UNITED STATES PATENT AND TRADEMARK OFFICE

Office Action Summary	Application No. 10/811,689	Applicant(s) HAUCK, ROBERT F.	
	Examiner Mark R. Wendell	Art Unit 3609

DETAILED ACTION***Drawings***

Marocco Figure 3

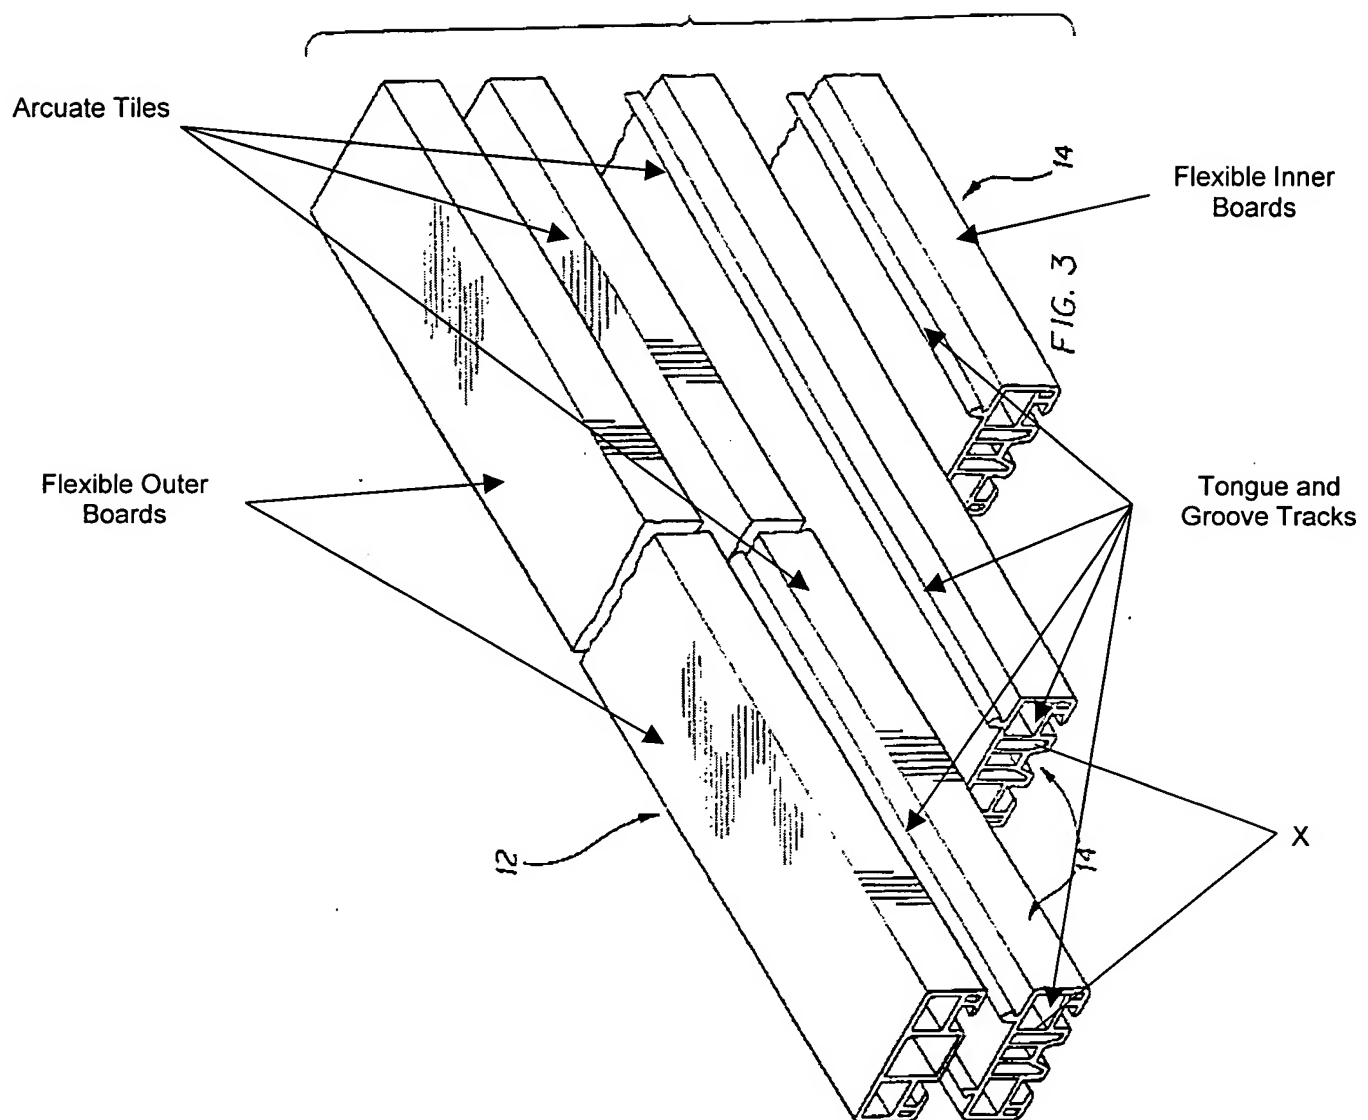
Claims 1-3, 5, 9-11, 13 are rejected under 35 U.S.C. 102(b) as being anticipated by Marocco (US 5699637). Regarding claims 1 and 9, Marocco illustrates in Figures 3-5 an arcuate architectural structure and component adapted to be in the structure comprising:

- A flexible outer board (Figure 5, item 14) forming a curved first outer surface including tongue and groove tracks (see Figure 3) formed along opposite ends;
- A flexible inner board (Figure 5, item 14) forming a curved second outer surface including tongue and groove tracks (see Figure 3) formed along opposite ends;
- A first and second plurality of arcuate tiles (see modified Figure 3 below) adapted to be arranged to form a third outer surface spanning the distance of the outer and inner boards (14);
- The plurality of tiles having a tongue and groove (see Figure 3) adapted to mate and lock with the outer and inner boards (14);

Regarding claims 2 and 10, Marocco illustrates in Figure 3 the first and second plurality of arcuate tiles having a third tongue and groove formed along a peripheral edge (designated by X in modified figure above) locking to the tongue and groove of the adjacent tile.

Regarding claims 3 and 11, Marocco illustrates in Figure 3 the first and second plurality of arcuate tiles being mirror images of one another.
